SANDY SPRINGS

BOARD OF APPEALS

Wednesday, February 4, 2026

- A. **2026-0002 V-25-54 - 701 Bass Way** — Request for a Variance from Sec. 6.1.2.B. to allow the encroachment of a building eave into the 30- foot side street setback.
(Presented by Helen Owens, Planner III/Zoning Administrator)
- B. **2026-0003 V-25-53 – 870 Edgewater Drive** – Request for a Variance from Sec. 6.1.2.B. to encroach into the 60- foot primary street setback by 20 feet for a new home.
(Presented by Helen Owens, Planner III/Zoning Administrator)
- C. **2026-0004 V-25-60 – 4825 Franklin Pond Road** – Request for a Variance from Sec. 11.7.2.B.3., and Sec. 6.1.2.B. to expand and alter nonconforming structures in the 35-foot rear setback and 50- foot primary street setback.
(Presented by LaQuita Williams, Planner II)

Sec. 6.1.2.B. Setback Encroachments All buildings and structures must be located at or behind the required setbacks, except as listed below. No building or structure can extend into a required buffer, easement (including private street easement) or public right-of-way

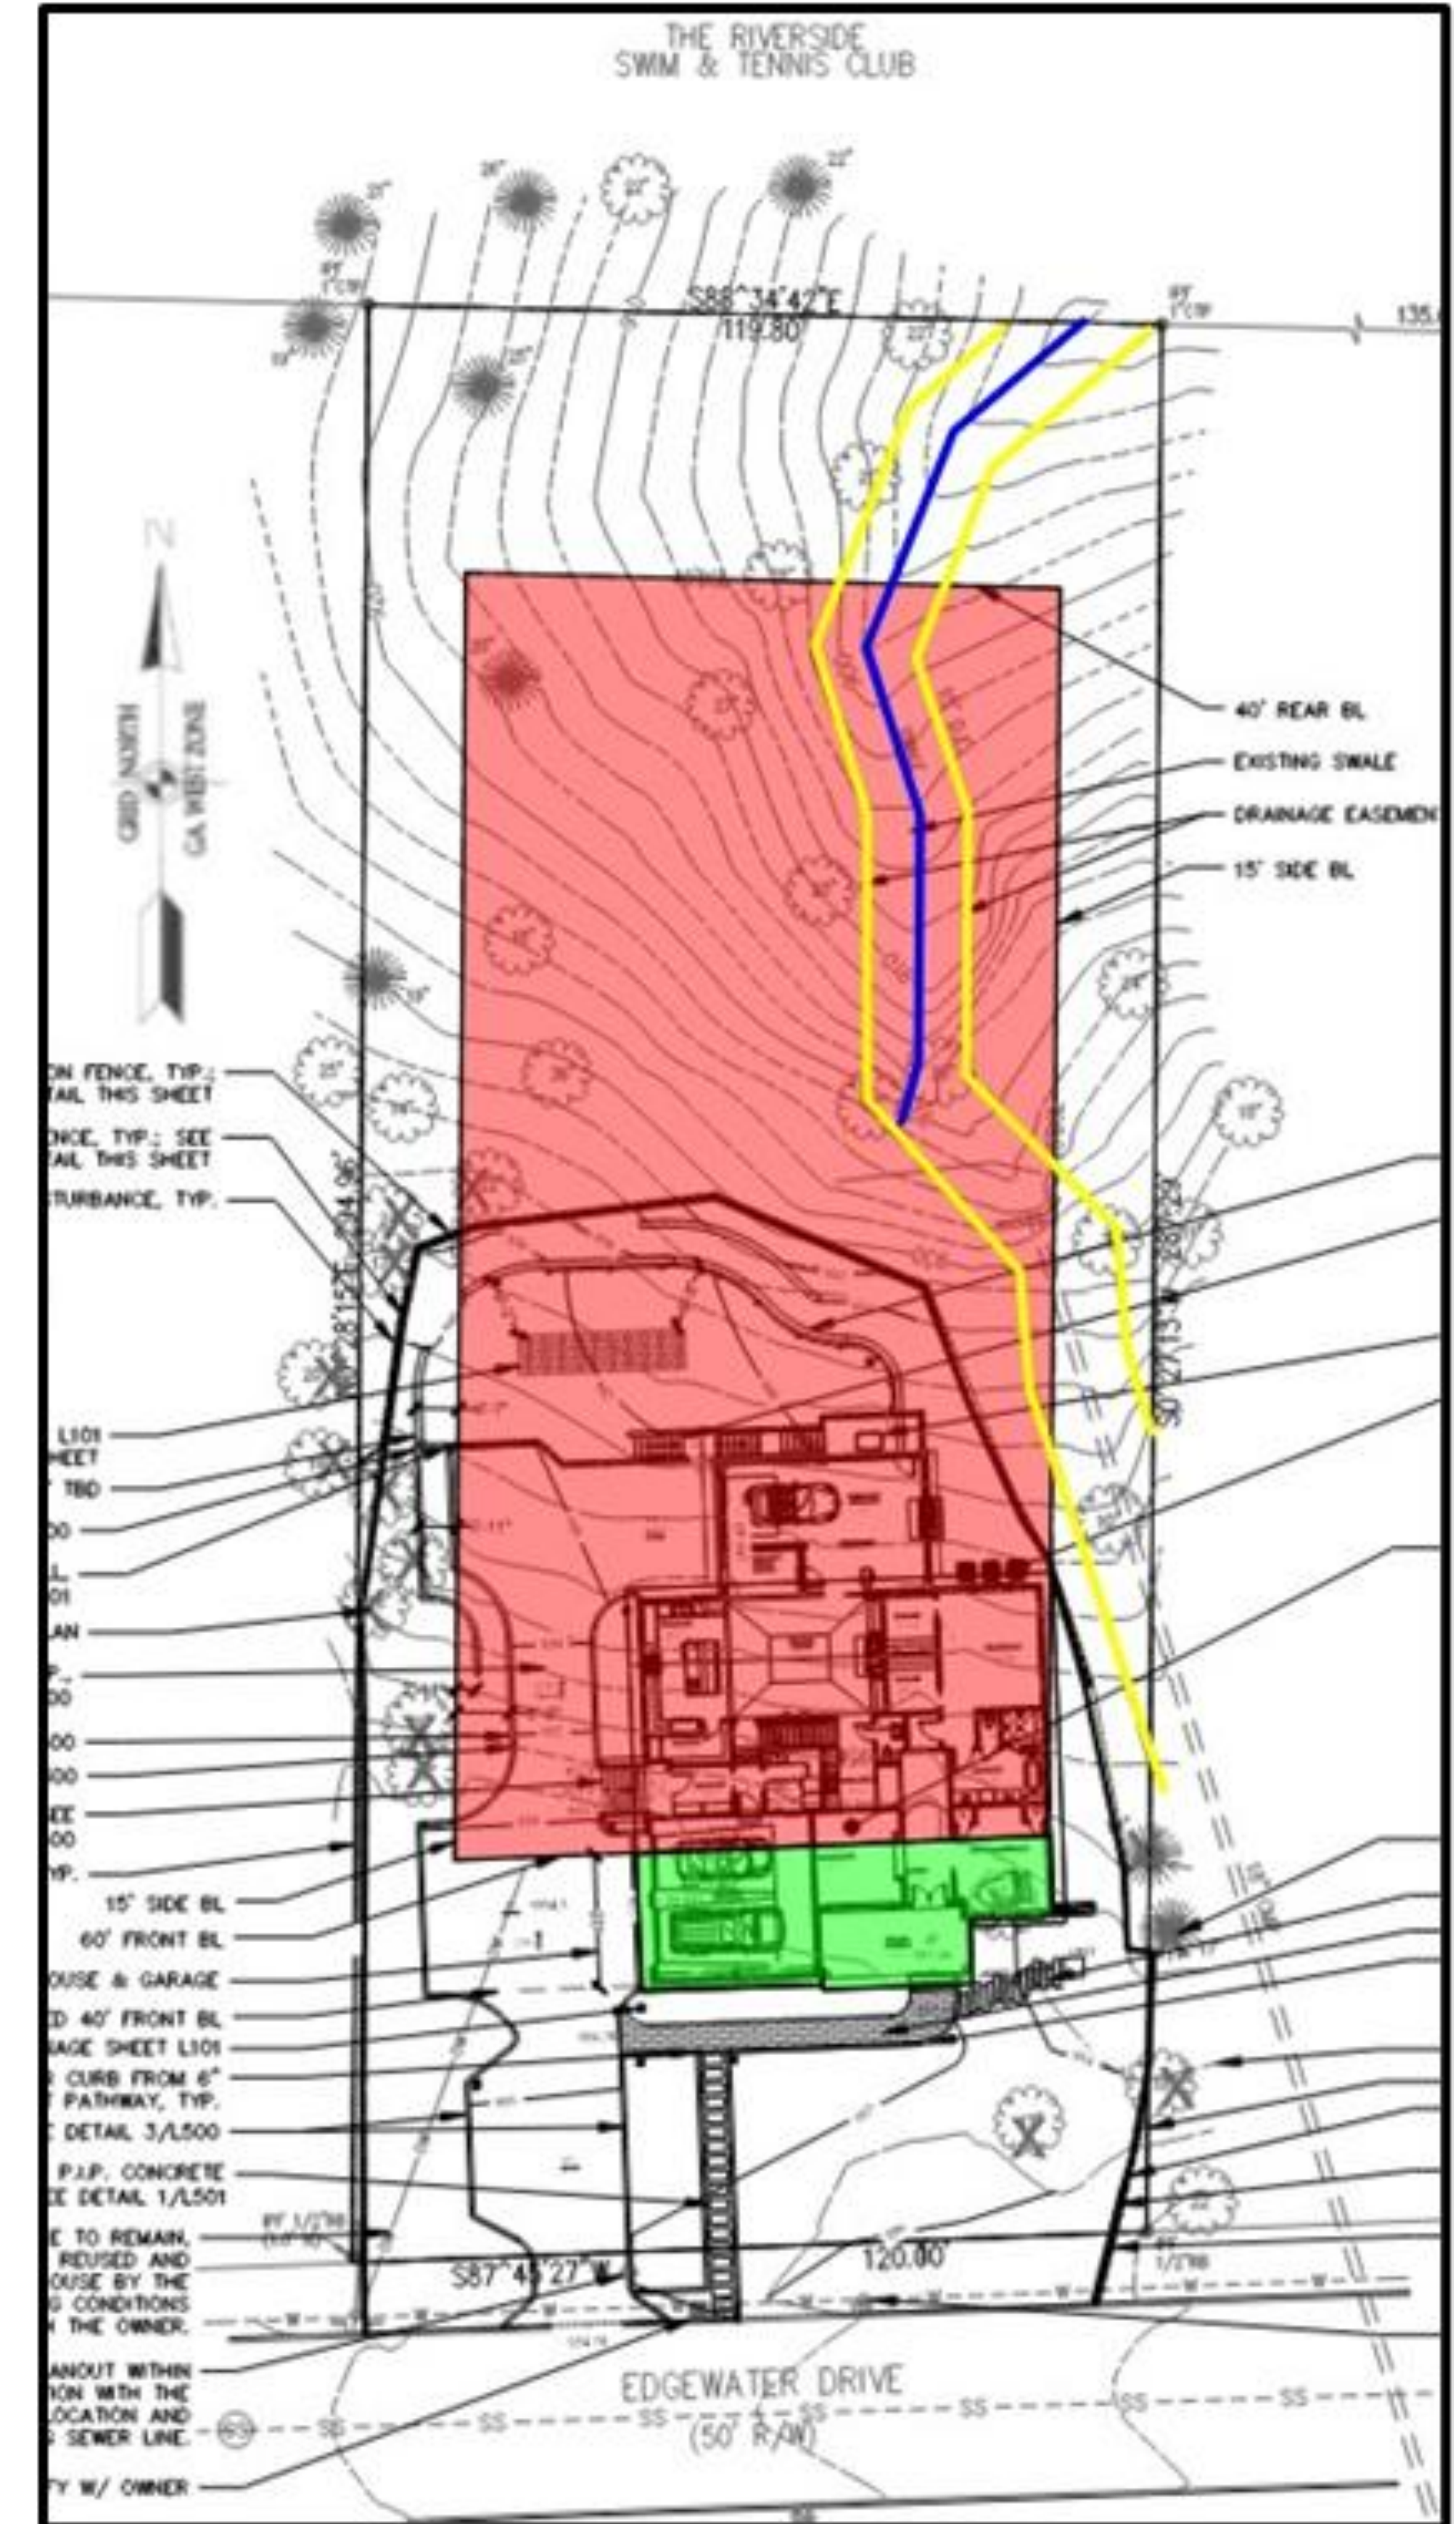
The applicants are proposing to build a new home that encroaches into the primary 60-foot street setback by 20 feet.

- The yellow lines indicate the existing drainage easement
- the blue line indicates the swale, the red shaded area indicates the buildable area
- the green shaded area indicates the 20 feet setback encroachment

Alternative Design

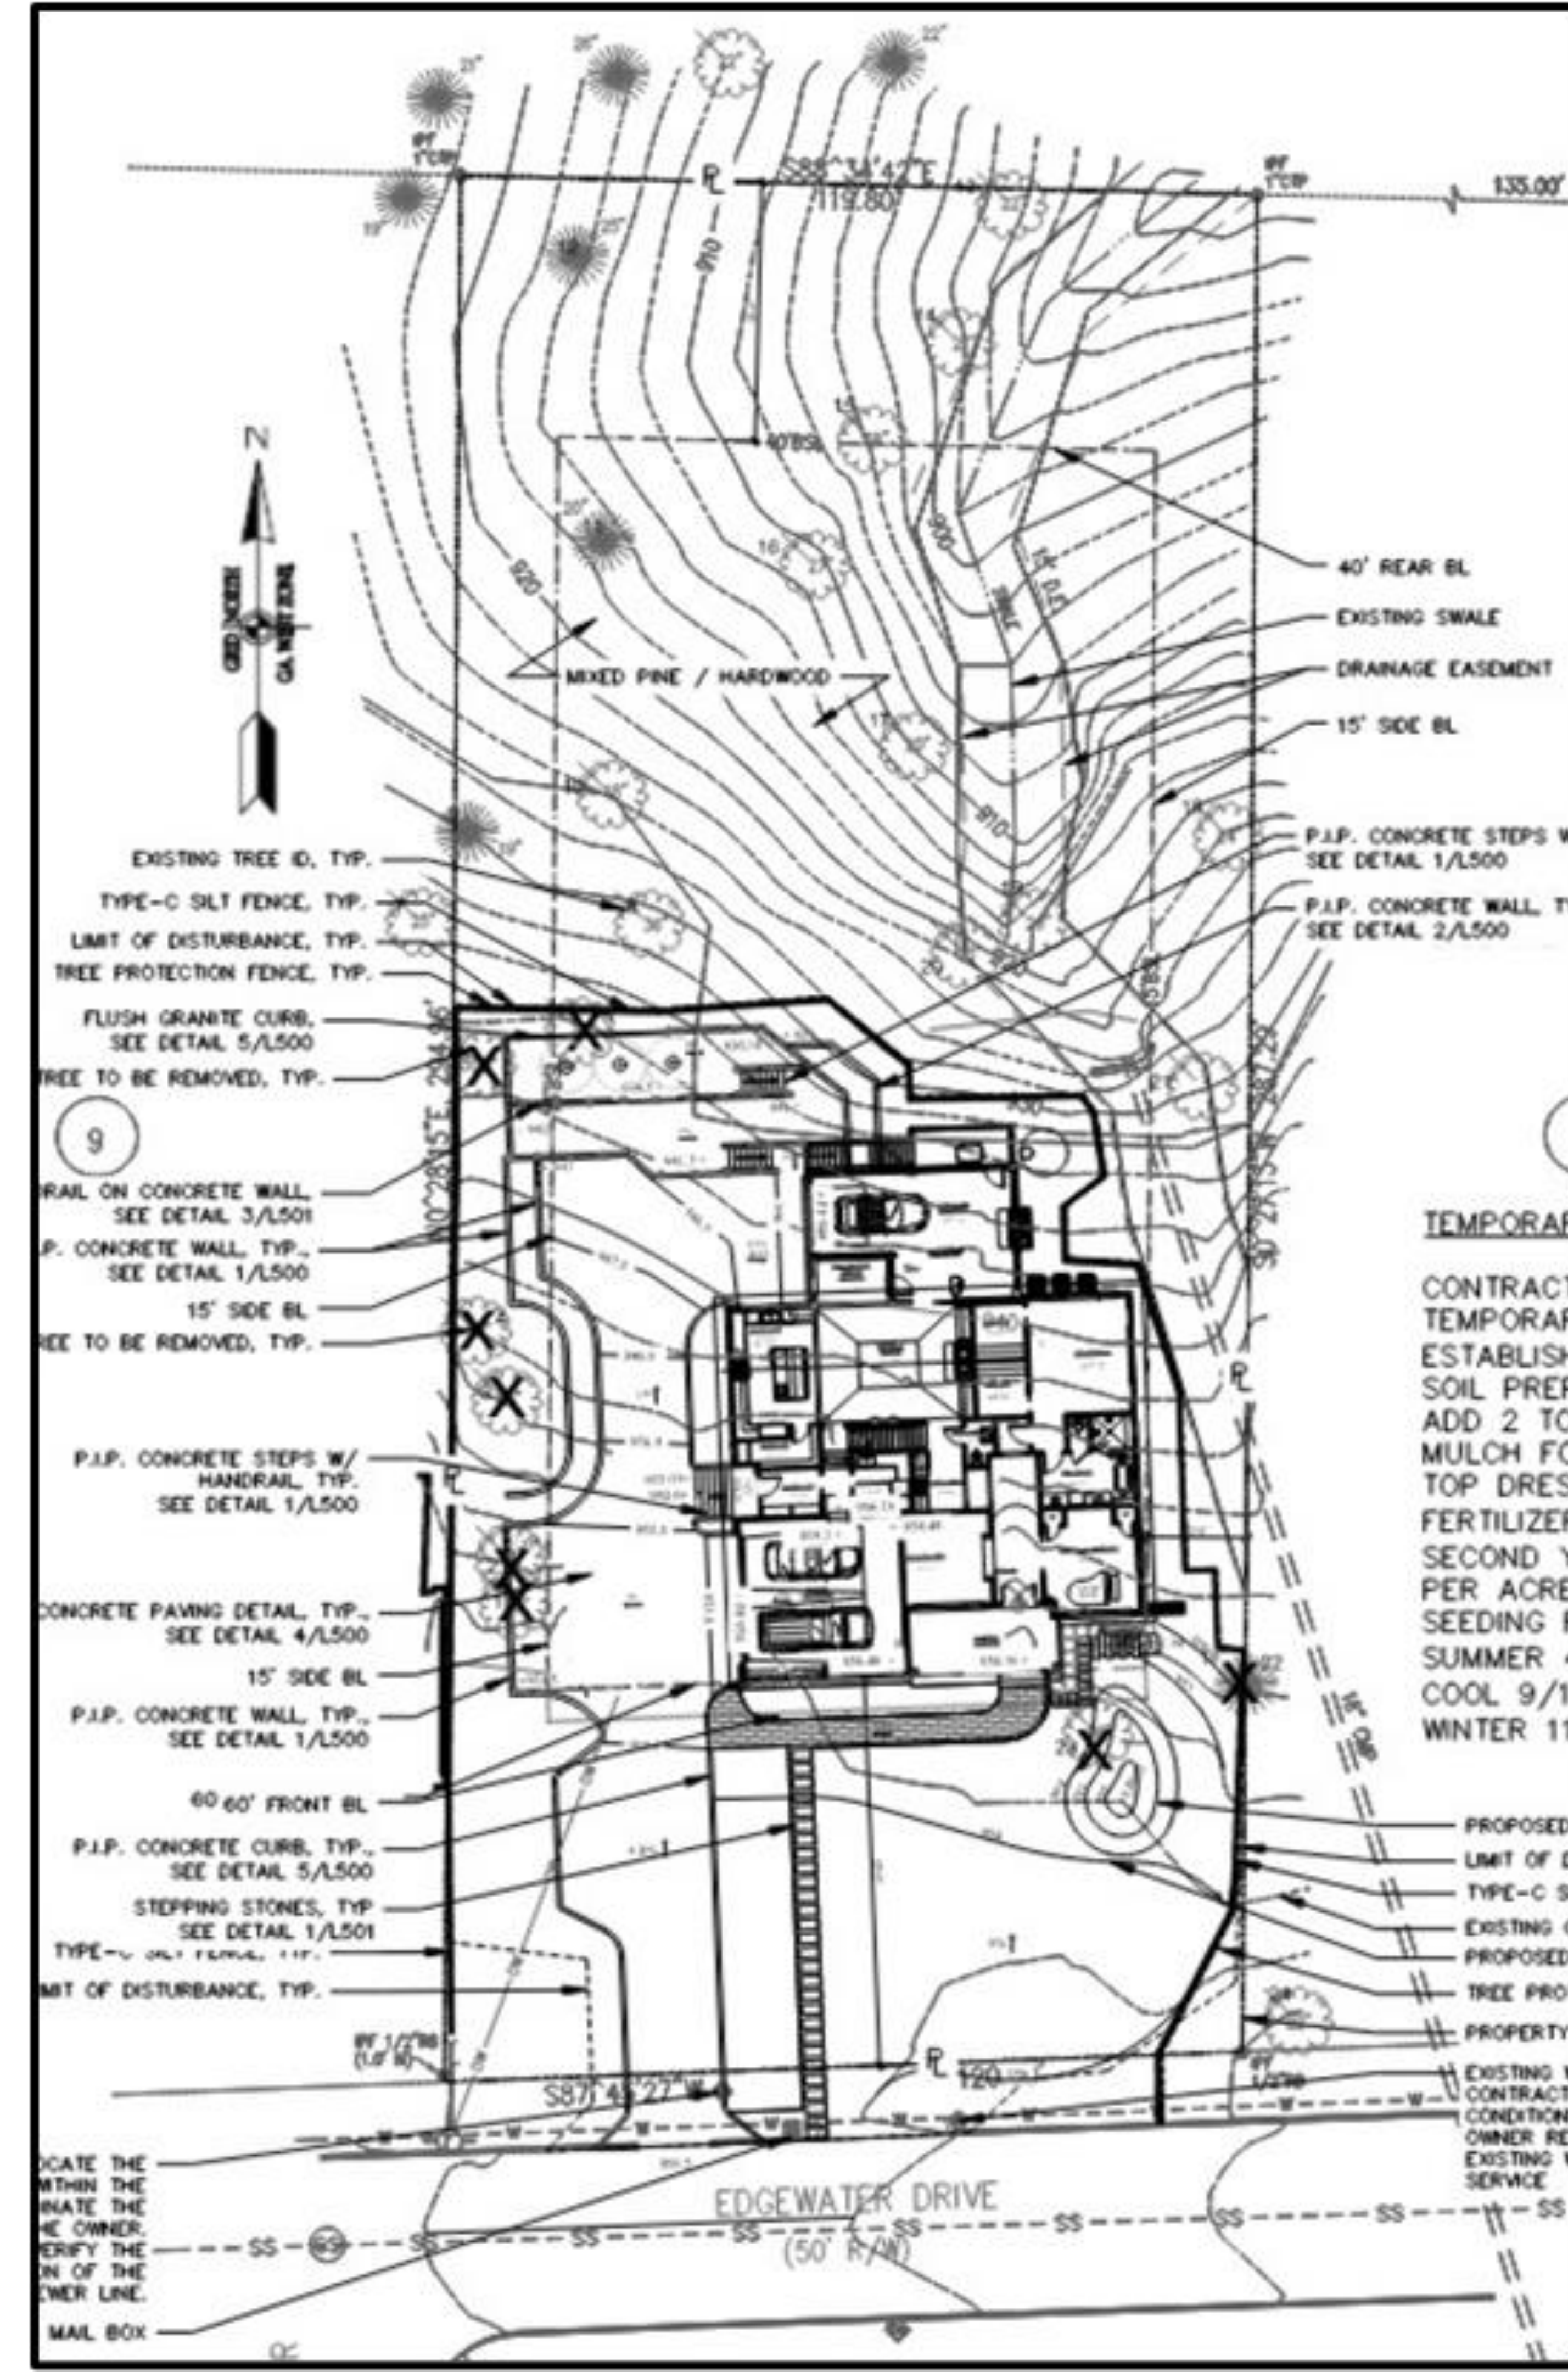
- The applicants provided a code compliant alternative design.
- All the site elements are located within the buildable area.
